designed for		R.De Salvo	
draw. by		G. Gennaro-PROMECC	
date		30-12-04	
scale		1/1	
title		HAM-OPTICAL BENCH	
DETAILS FILTER		LIGO-D051123-04-D	
ref. from		105-106	
		A 2

26

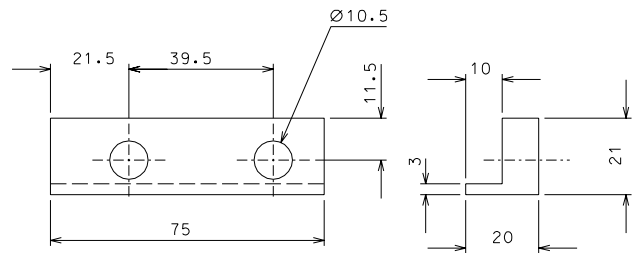
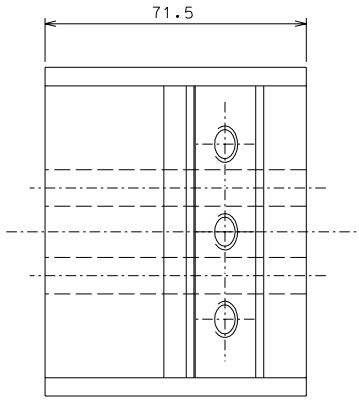
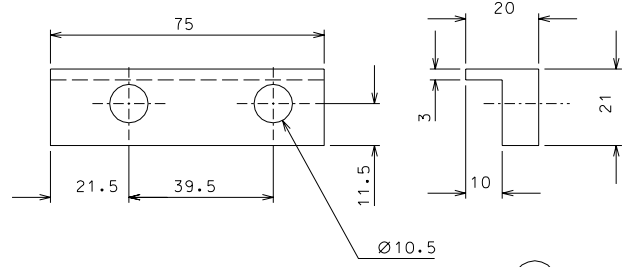
added missing dimension	30-05-06		
eliminated part 72	06-05-06		
modified detail 26	09-04-06		
modified n° parts of detail 28	10-02-06		
ref.	note	date	signature
